# Access Compliance Report

## Public Rights-of-Way

### (Curb Ramps)

| Intersection ID: 16634 | Main Street: OLD_PINEVILLE_RD | Cross Street: YANCEY_RD | Location: SW           |

| ADA ID: 9CDAB3ACAE39   | Ramp Type: PerpDiag           | Initial Pass/Fail: Pass | Overall Compliance: No |

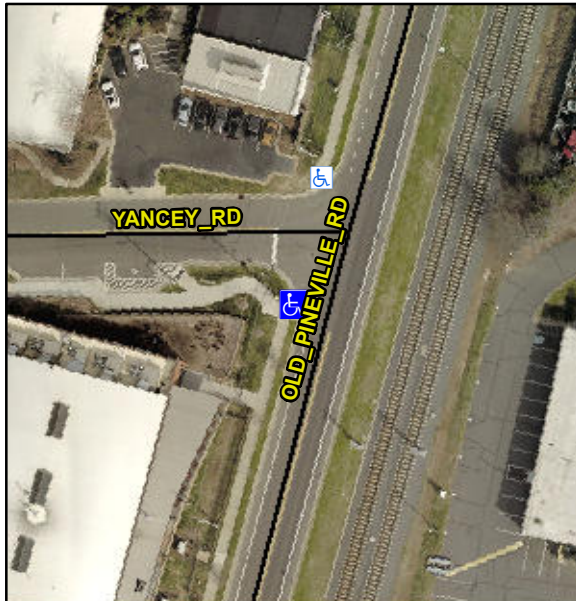
**Not Found, R304.2.2-Perp, R304.3.2-Para**

| Compliance | Description           | Data   | Compliance | Description                 | Data  |
|------------|-----------------------|--------|------------|-----------------------------|-------|
| No         | Landing Slope (%)     | 2.8    | Yes        | DWS Length (in)             | 24.0  |

**Remove & Replace Curb Ramp With Two New Directional Ramps or Equivalent.**
